United States Patent and Trademark Office

APPLICATION NO.	FILING DATE	FIRST NAMED INVENTOR	ATTORNEY DOCKET NO.	CONFIRMATION NO.
10/533,661	11/14/2005	Francis Guichard	0002224USU/2278	8650
Charles N Rug	7590 12/10/2007 giero	,	EXAM	INER
Ohlandt Greeley Ruggiero & Perle 10th Floor One Landmark Square Stamford, CT 06901-2682			KAVANAUGH, JOHN T	
			ART UNIT	PAPER NUMBER
			3728	
			MAIL DATE	DELIVERY MODE
			12/10/2007	PAPER

DETAILED ACTION

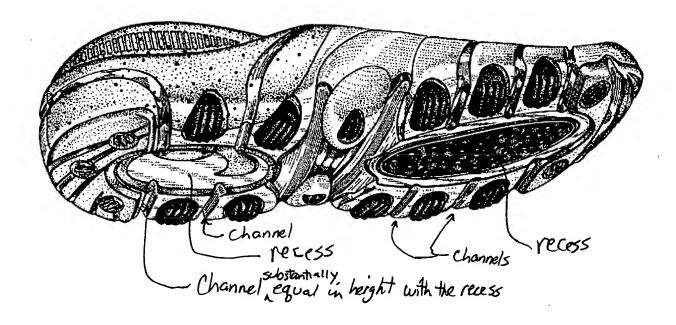
Gardner teaches a sole for walking having structure as claimed including a plurality of recess (7) and a plurality of decompression channels (passageways between proturbences 9; see col. 2, lines 39-44).
